**Re: Lot 3 Block 9 Unit 18 Volcano Cliffs, S.A.D. 228
7900 Agular NW
Request for Permanent C.O. – Not Accepted
Engineer's Stamp dated: 10-12-2020 (D10D003I3)
Certification dated: 8/23/2021**

DRAINAGE AND TRANSPORTATION INFORMATION SHEET (REV 11/2018)

ENGINEER'S SEAL DAVID SOULE NEW MEXICO 14522 REGISTERED PROFESSIONAL ENGINEER	LOT 3 BLOCK 9 UNIT 18 VC 7900 AGUILAR ST GRADING AND DRAINAGE PLAN	DRAWN BY DEM DATE 10-11-20 LOT 3 BLOCK 9 UNIT 18 VC.DWG
DAVID SOULE P.E. #14522	Río Grande Engineering 1806 CENTRAL AVENUE SE SUITE 201 ALBUQUERQUE, NM 87106 (505) 872-0689	SHEET # C1 JOB #

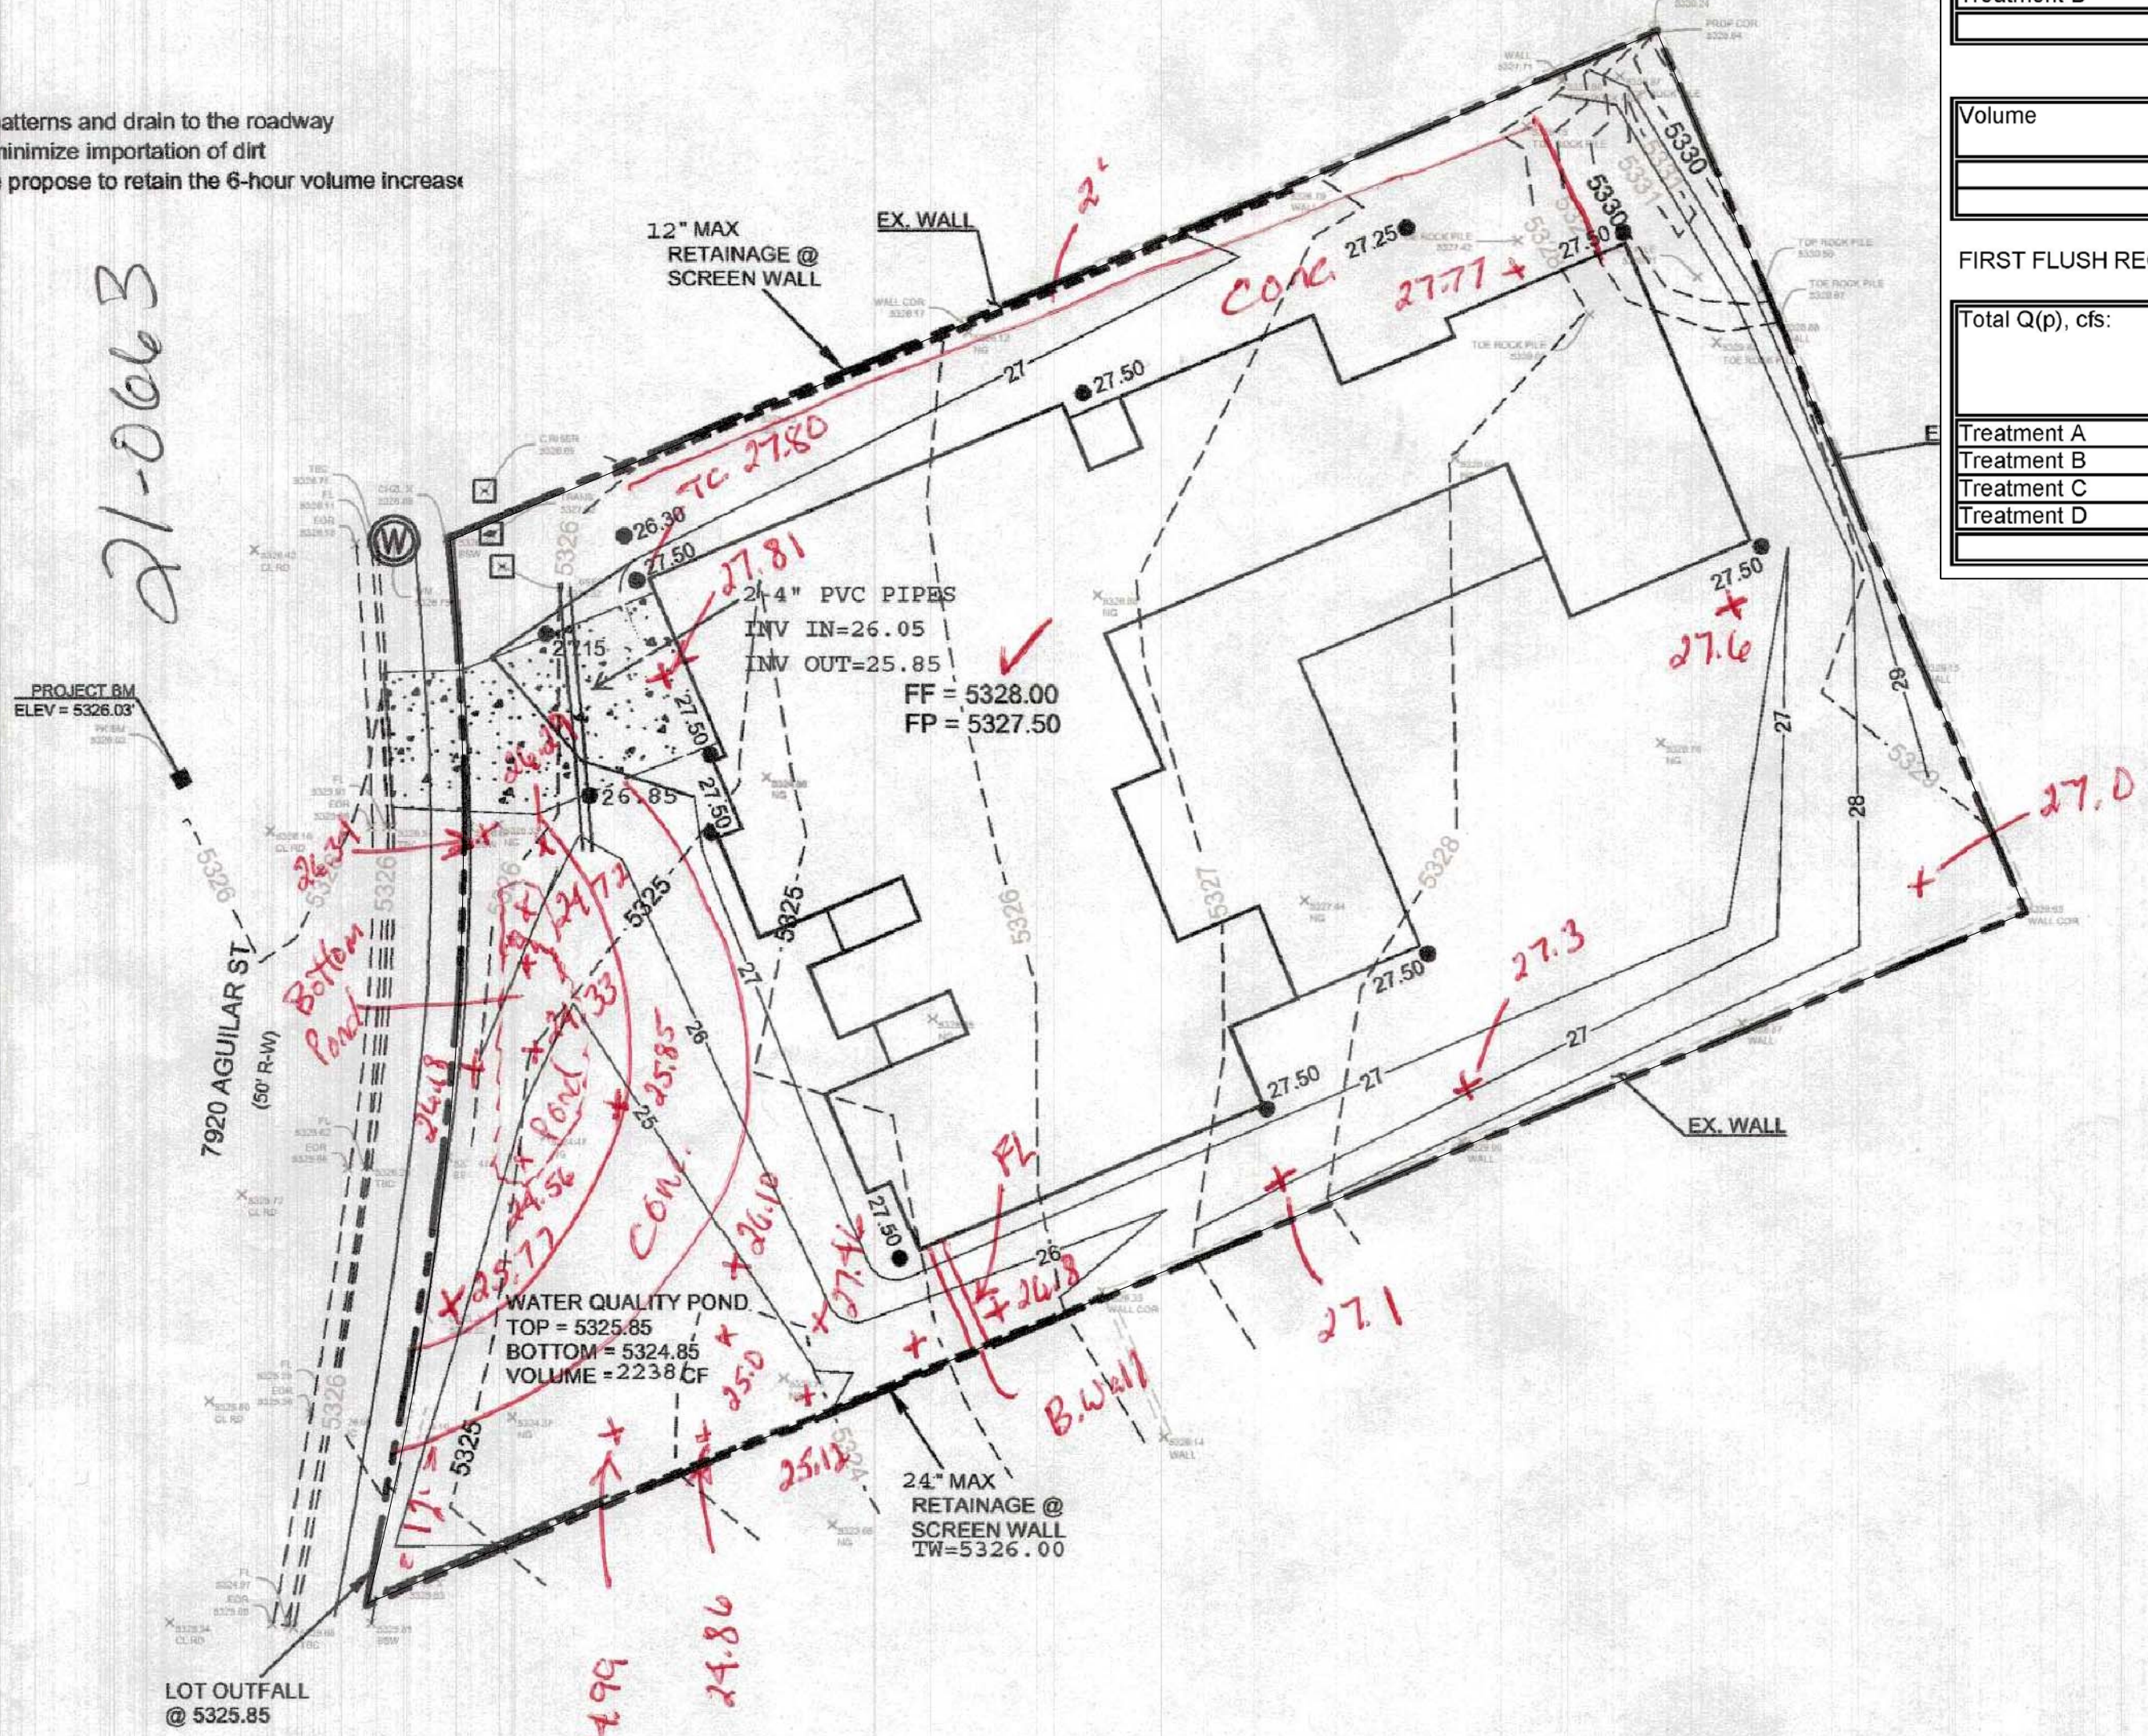
Based on the Certification received 8/24/2021, this site cannot be accepted for release of Certificate of Occupancy by Hydrology until the following comments are addressed.

- Provide a letter from David Soule stating he gives his approval for you to use his G&D plan for CO.
